MEMORANDUM

SUBJECT: Seismic Evaluation, NGL #C6A, API # 123-40968

SUBJECT: Need for Seismic Evaluation

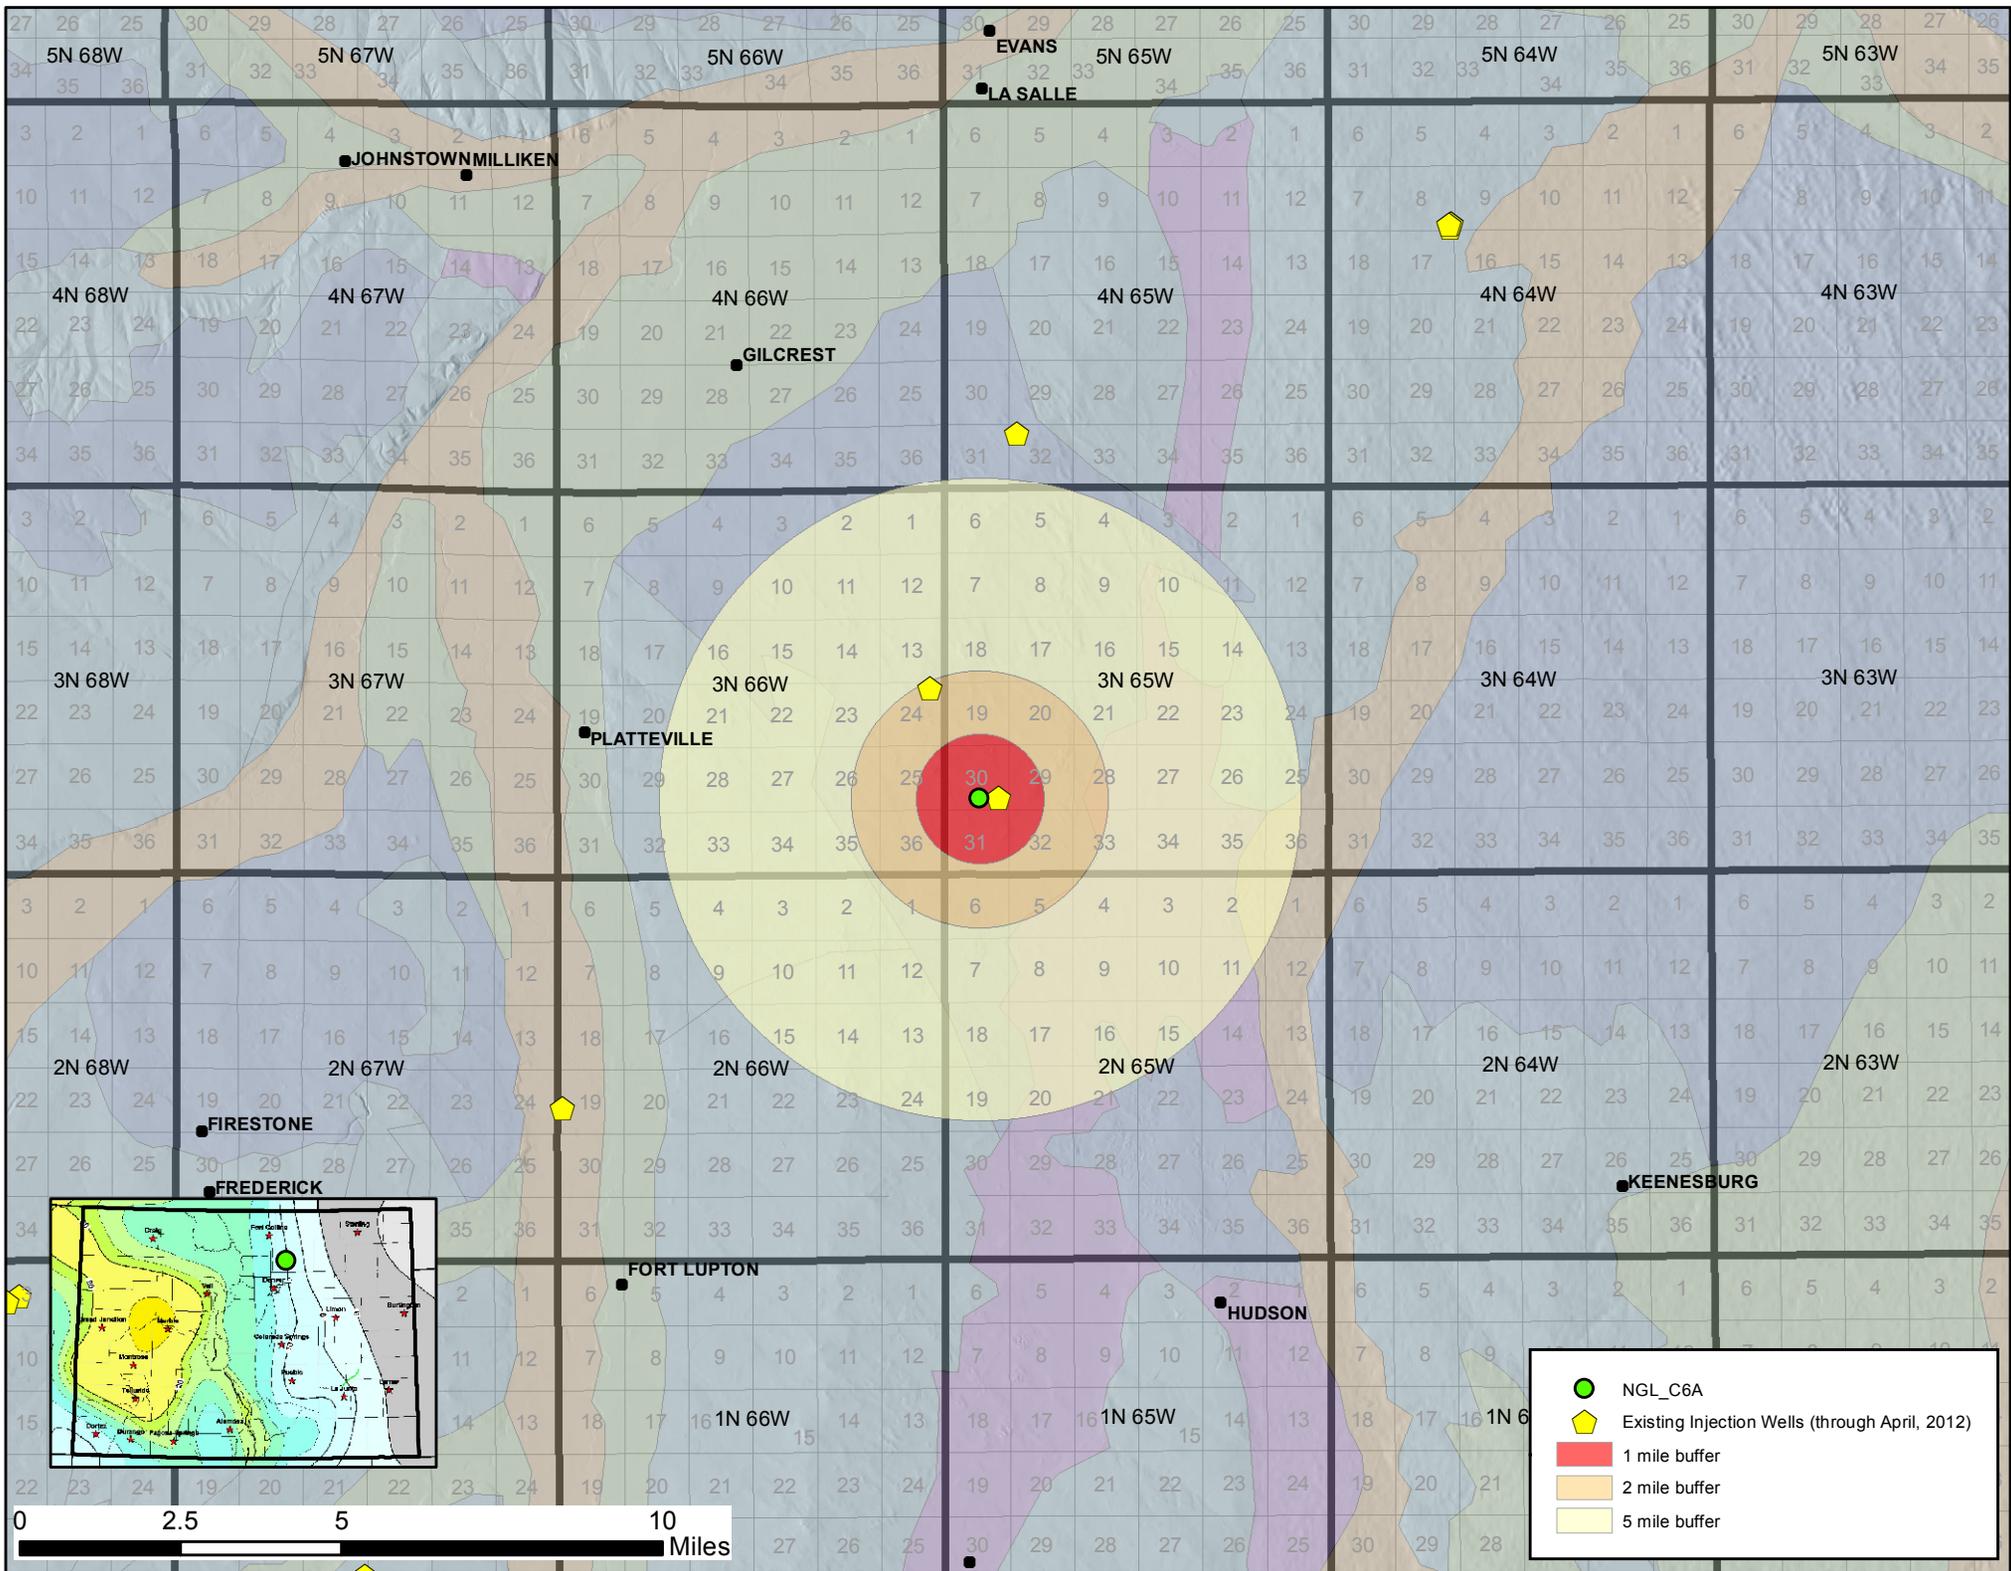
No earthquakes or mapped faults are within ten miles of the proposed well according to published geologic maps.

The proposed high volume (10,000 – 19,440 bbls/day) of water disposal should be approached cautiously. If permitted, the operator should increase the injection rate via steps with careful observations from a local seismometer being made. If a rate step is reached that has induced seismic events occurring with greater frequency and magnitude, it is recommended a cap on the permitted injection volume be placed.

While the likelihood of triggering earthquakes at this location appears low, caution should be taken as the deepest proposed injection interval is proximal to the Precambrian basement. If any seismic

activity is detected subsequent to the initiation of injection, a local seismometer would help determine whether activity is related to the injection, and allow for possible management of injection volumes and rates.
